-----Original Message-----From: Wayne Pein <wpein@nc.rr.com> Sent: Wednesday, February 16, 2022 2:29 PM To: Town Council <mayorandcouncil@townofchapelhill.org> Subject: Door Zone Bike Lane on Country Club Road

Door Zone Bike Lane on Country Club Road and misplaced Shared Lane Markings

February 16, 2022

Image 1. The parking lane on Country Club Road is 8' wide, the Door Zone Bike Lane is 6', and the travel lane is just 10'.

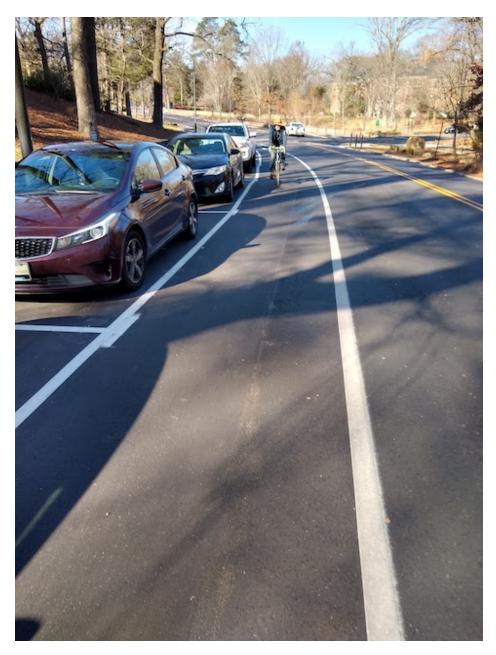
Parked vehicles can abut the parking limit line. Opened doors can extend 3.5', leaving just 2.5' of Bike Lane clear space. Bicyclists are 2.5' wide but need 4' of clear operating space plus shy distances. Trucks, buses, and landscape trailers are 8.5' wide not including mirrors, and can abut the Bike Lane.

This design is fatally flawed. Bicyclists should not have to tightrope, staying far left in the Bike Lane to defend against opened doors on their right while being skimmed on the left by close passing motor vehicles.

Image 3. Rather than a Bike Lane, it should be a buffer showing the area to avoid.

Image 4. Shared Lane Marking in the Door Zone on Ridge
Road.

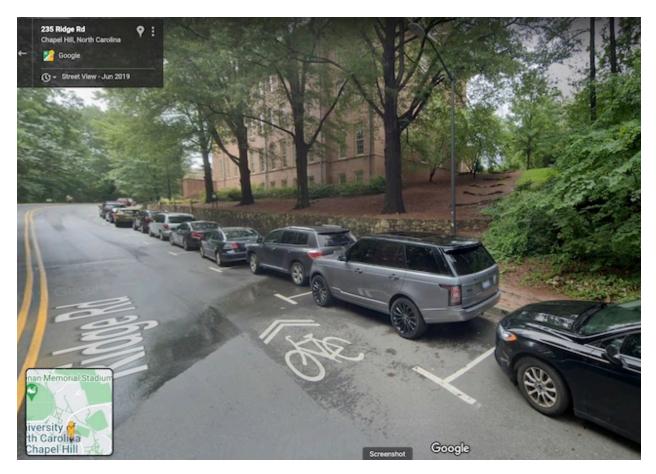
This and similar others are willful miseducation; they should be at lane center.
